<b>REPORT TO:</b>	Emma McLean [16/6/22]	<b>CC:</b>	
<b>FROM:</b>	David K. Wanty, Wanty Transportation Consultancy; CPEng, M.ITE		
<b>RM200084:</b>	758 & 760 High St Boulcott – 48 unit retirement CRD		
<b>ISSUE DATE:</b>	19/6/2022	<b>REVISED:</b>	<b>SITE VISIT(S):</b>

<b>REPORT TO:</b>	Peter McDonald [30/7/21]	<b>CC:</b>
<b>FROM:</b>	David K. Wanty, Wanty Transportation Consultancy; CPEng, M.ITE	
<b>PreApp:</b>	758 & 760 High St Boulcott - Ropata (Lodge) Village	
<b>ISSUE DATE:</b>	30/7/2021	<b>REVISED:</b>
		<b>SITE VISIT(S):</b>

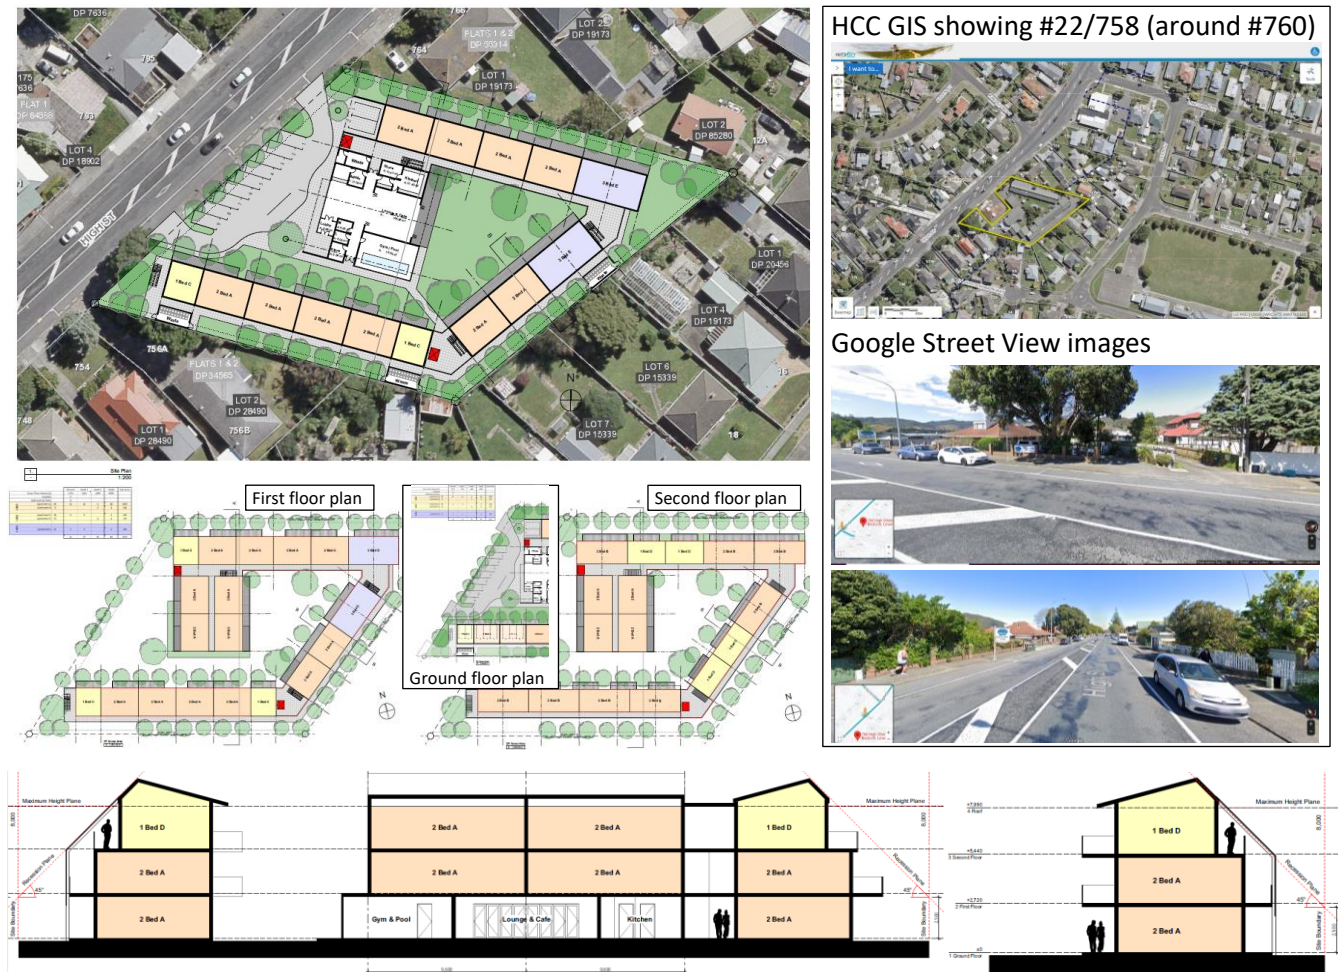
Two inward opening nominal 5 m combined gates within a 6 m access alongside boundary landscaping strip is proposed. The vehicle gates keypad is not shown but will presumably be on the right when entering; along with the control loops for auto exiting (and any exit control pad) these should be noted on the plans and mentioned in the Application documents. The pedestrian sight visibility triangle is not met and needs to be. Pedestrian access (and gate) is separated from the driveway access beside the “Bins/Waste” screened area.

The plans do not show any roadmarking changes (dashed yellow lines) as a result of the proposed access and closure of existing crossings.

Three 5.0x2.5 m right angle parking spaces are provided opposite the access for which tracking curves were not provided as it was stated “*vehicle access here being less constrained*” – this is the case for forward entry but not for reversing exit so should be provided. Consistent with AS/NZS2890.1 end space 1 should ideally be

widened to better facilitate reversing back. By showing the manoeuvring paths a kerb extension to the landscaping strip could be considered for a tree planting (the dual vehicle tracking for entry exit seems too conservative but would need to be taken into account).

Within the central area 11 spaces are shown of which space 10 is marked as accessible but in reality so could space 11, noting that the dimensions do not match with that shown. The spaces are 5.0x2.5 with a 7.0 m aisle and 1.5 m blind aisle extension (no end space widening). The TIA states that of the 14 spaces in total, 2 will be dedicated to staff, 2 for visitors, 8 spaces for lease by tenants, and 1 dedicated electric vehicle carpark (*"An electric vehicle (EV) will be purchased as part of the development of the proposed Retirement Village. The EV will operate under a car share scheme for residents of the village."*). Plus presumably 1 accessible.

The EV space is not indicated and it more be logical for the charging unit to be set up for two spaces, one either side as is normal practice. The charging unit should be shown to ensure that there would remain sufficient footpath space for the adjacent footpath to be an accessible ramp – the ramp for the accessible space should also be shown and wheel stops to prevent overhang onto the footpath by the lounge/lobby. The AEE says that *"A maximum of five staff are expected to be onsite at any one time"*. It might be more sensible that the 3 spaces opposite the access are dedicated for staff, including the nighttime duty manager (possibly shared space with the café manager if operating times are compatible), noting the on-street parking in front of the existing site is time restricted.

With the two landscaping strips within the central carparking proposed, if these were not needed an additional space could be provided on the southern side (to increase it from six to seven spaces) and remove the inconvenience of landscaping between the spaces which would especially affect the elderly. No "set-down/pick-up" space is provided as would likely be most useful for the number of units for the elderly without any dedicated parking – provision of such a (P5/Taxi/Uber) space is recommended.

No turning area is shown as is required. It is suggested that (kerbed) area next to the accessible space could be marked to be kept clear so that a visitor could reverse into it (provided the proposed tree was relocated) to exit in the forward direction. There is no mention in the TIA or AEE regarding servicing of the pool, gym and café. The "Private Courtyard" has much planting (more in the landscape plan than in the Site Plan) so it is unclear how supplies of pool chemicals etc (and new/repaired gym gear) are safely delivered on-site with no loading or turning area.

The proposal is for rubbish/recycling trucks to reverse from High Street to the "Bins/Waste" area which while not ideal, is considered tolerable. As shown however the rubbish truck would completely block the footpath while loading so the area needs some redesign so that this need not occur (gates further from the footpath).

The main non-compliance is the lack of a turning area. A "set-down/pick-up" parking space is recommended and consideration of servicing of the pool, and revision of the parking area & dedicated (show which) spaces. The control mechanisms for the access gates need showing (& EV charging unit). Show roadmarking changes. Ensure that the pedestrian sight visibility triangle is met (lower end of fence as need be). Redesign bin area.
